**ADDENDUM NO. THREE**

**PROJECT: Johnson County Recycling Center**

**PROJECT NUMBER: 23122**

**DATE OF ADDENDUM: June 3, 2024**

1. Drawing Number: 1000  
Change:

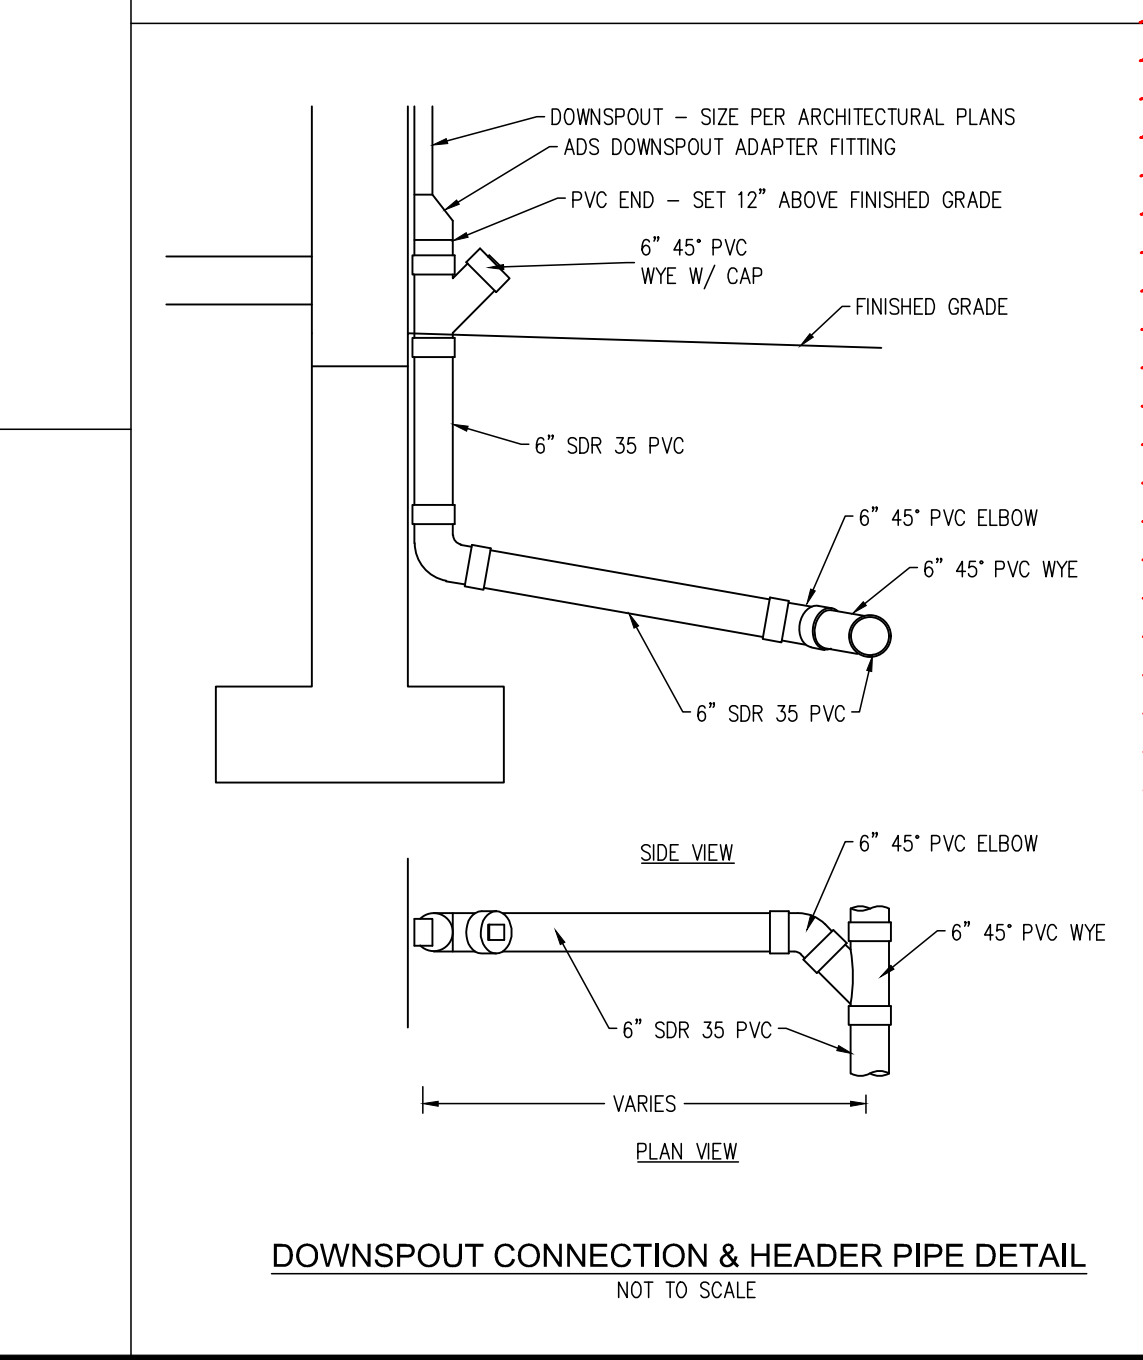
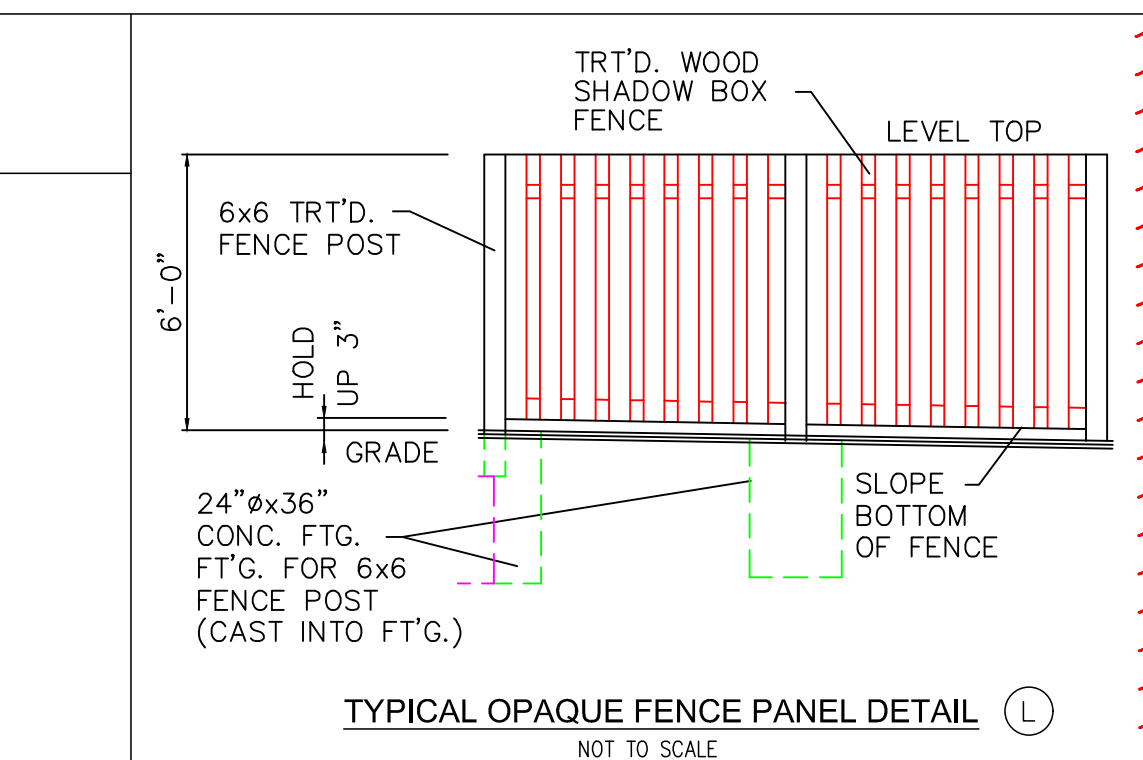
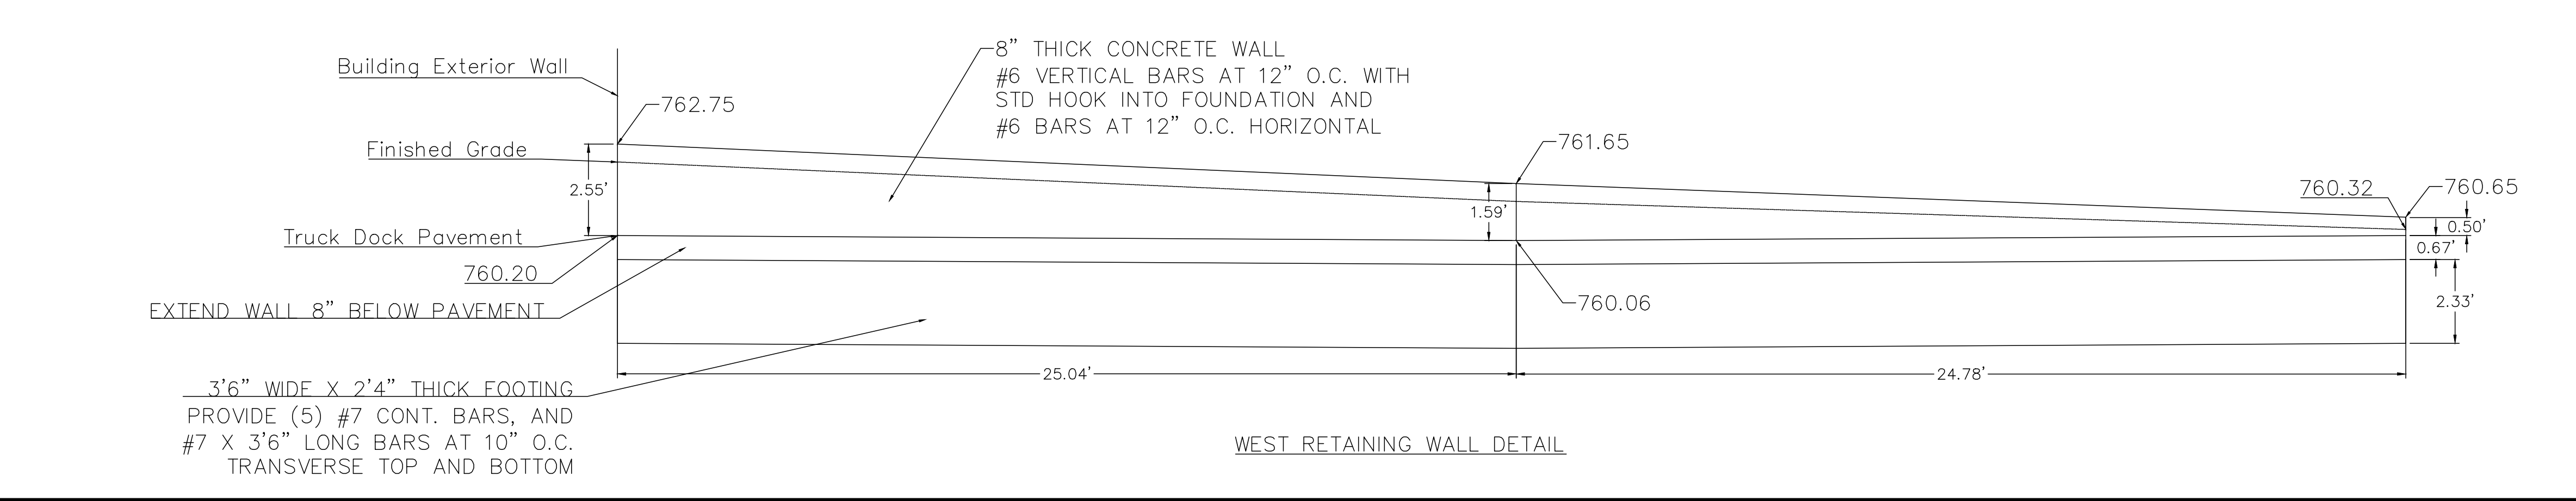
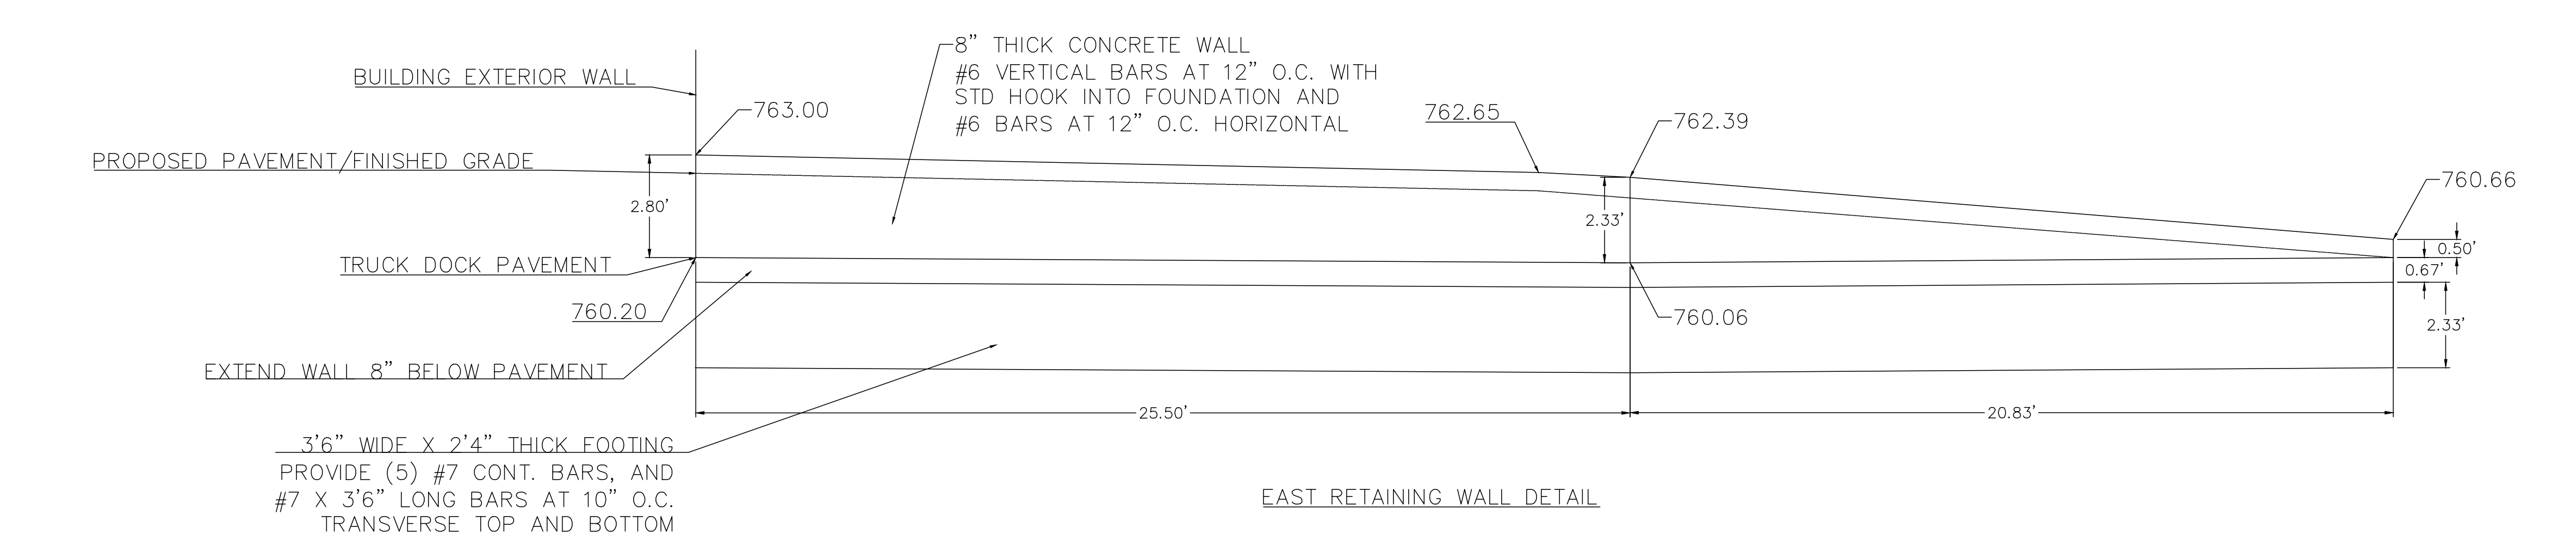
Q: How are the fences to terminate? Will they connect to existing fence? Or do they just end out in space??

Q: Item M on Plan Page 300 says "retaining wall (see detail -Sheet 1000). Two elevations are shown on Sheet 1000, but I don't see any notes about size of footing, wall thickness, reinforcing, etc. Please clarify.

Updated Details

A: The fence is free-standing and does not tie-in to any existing fences. It will end as it is shown on the plans. The detail for the fence is on Sheet 1000.

A: Additional details for the retaining wall including footing, thickness, and reinforcing are shown on Sheet 1000.
